Amendment No. 0002
02 March 2004

SUBJECT: Amendment No. 0002 to Specifications and Drawings for Construction of
Perry Creek Flood Protection, Phase 4, Sioux City, IA
Solicitation No. W9128F-04-B-0008.

**PERRY CREEK PHASE 4
DRAWING SHEET S-16
AMENDMENT NO. 0002**

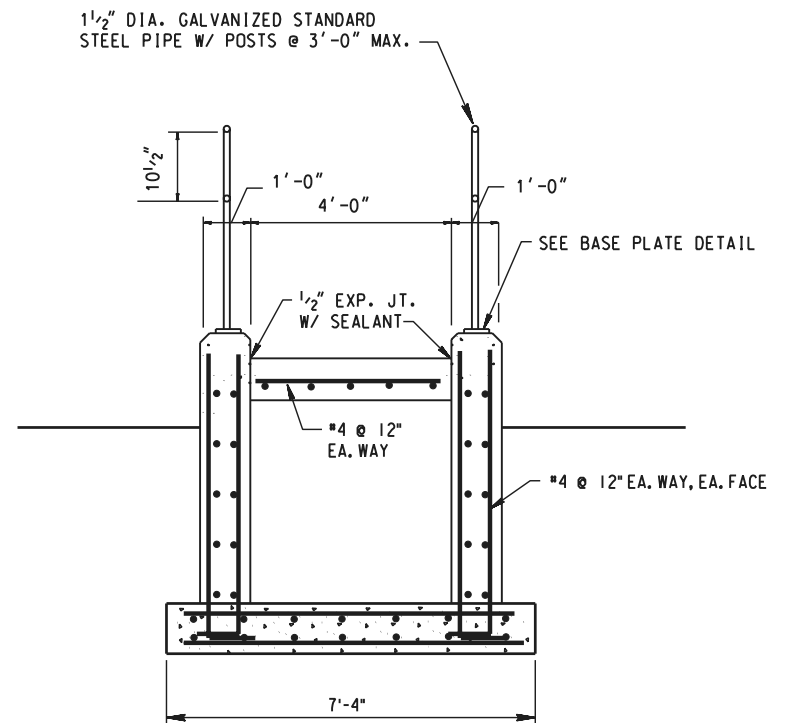
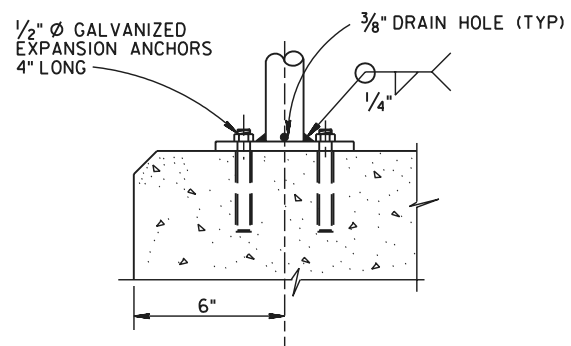
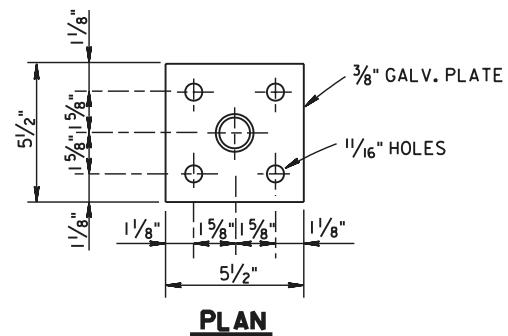
(2) Sheet S-16, delete Section 2 and Section 3 and substitute attached revised Section 2 and Section 3 and new "BASE PLATE DETAIL."

SECTION 2

SECTION 3

TYPICAL INVERTED T- WALLS, TYPES A-G

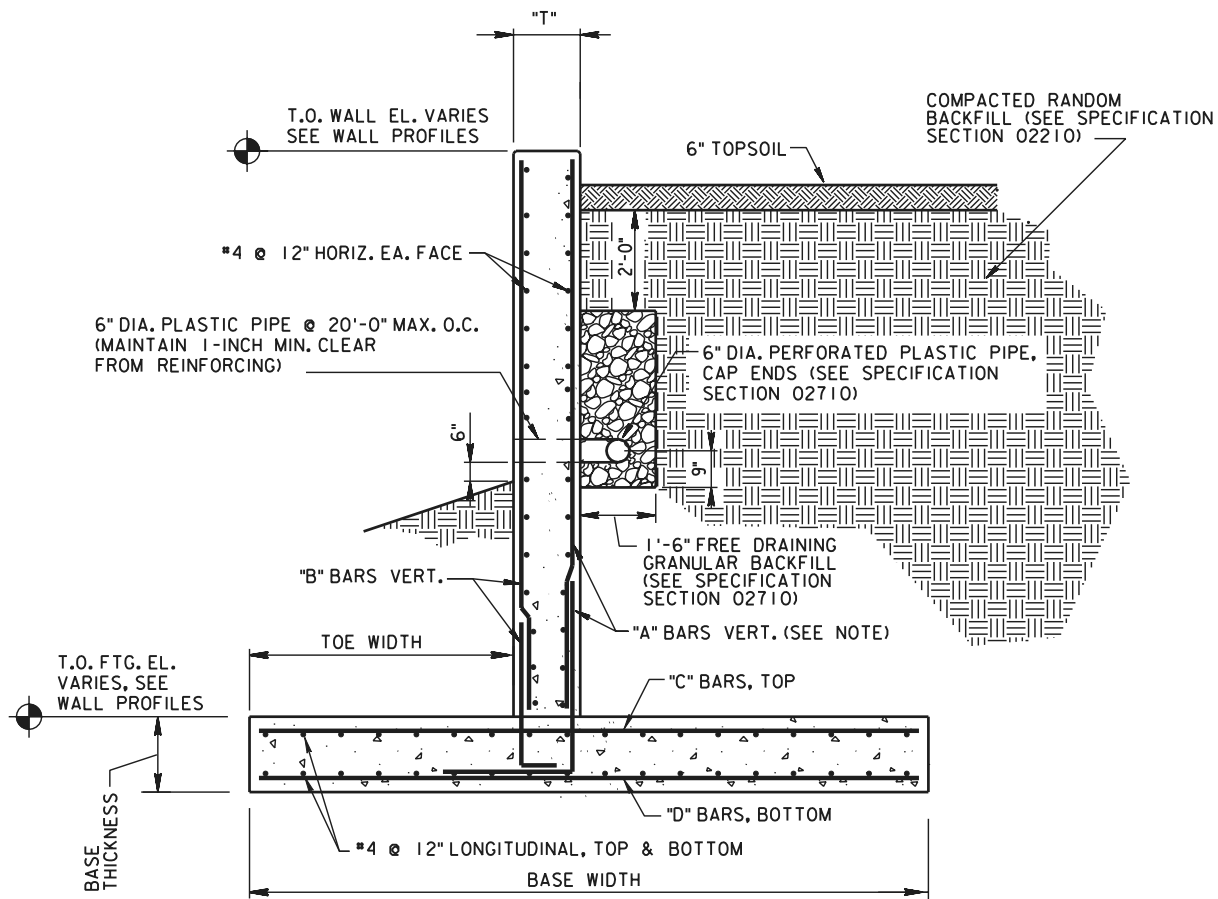
- (3) Sheet S-17,
- a) Delete detail "TYPICAL INVERTED T-WALLS, TYPE A-G" and substitute attached revised "TYPICAL INVERTED T-WALLS, TYPE A-G."
 - b) Detail "SEGMENTAL CONCRETE BLOCK GRAVITY RETAINING WALL" delete "6" MIN. COMPACTED GRANULAR BASE," and substitute "6" MIN. COMPACTED AGGREGATE BASE LEVELING PAD."

NOTE:
HORIZONTAL LEGS OF BARS DESIGNATED 'A BARS VERT' SHALL BE 28 INCHES
FOR #6 BARS, 33 INCHES FOR #7 BARS, 37 INCHES FOR #8 BARS, AND 42 INCHES
FOR #9 BARS. HOOKS ON BARS DESIGNATED 'B BARS VERT' SHALL BE A
STANDARD HOOK OF 12 BAR DIAMETERS.
